Intel[®] Pentium[®] II Xeon[™] Processor Specification Update

Release Date: March 2001

Order Number: 243776-030

The Pentium[®] II Xeon processor may contain design defects or errors known as errata that may cause the product to deviate from published specifications. Current characterized errata are documented in this Specification Update.

Figure 1. An Example of Microcontroller Driven Thermal Management

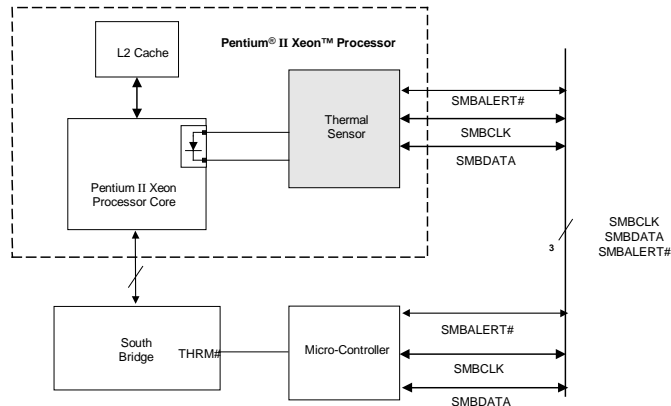
D30. Thermal Sensor May Assert SMBALERT# Incorrectly

Problem: The Pentium II Xeon processor has a thermal sensor that monitors the processor core's temperature. The thermal sensor asserts SMBALERT# if the processor temperature exceeds the temperature limits set in the Alarm Threshold Registers (T_{HIGH} , T_{LOW}). It also sets the corresponding Status Register bits to identify the cause of the interrupt. Figure 1 gives one example of the how the SMBALERT# signal could be used in a system.

Under the conditions described below, the thermal sensor incorrectly generates the SMBALERT# interrupt. *All* of the following conditions must be met to trigger a false interrupt:

Workaround: Three different (mutually exclusive) workarounds are possible:

1. Before servicing an interrupt from the thermal sensor, read and compare the processor thermal reading with the threshold limits (T_{HIGH} or T_{LOW}). Figures 2 and 3 provide basic flowcharts for the implementation of this workaround in an interrupt driven system.
2. If the firmware implemented polls the Status Register only, then before taking any action, re-read the temperature register and do a comparison with the alarm threshold limits (T_{HIGH} or T_{LOW}) to determine if the value is actually still within the temperature window.
3. Use a temperature polling scheme to monitor the processor temperature
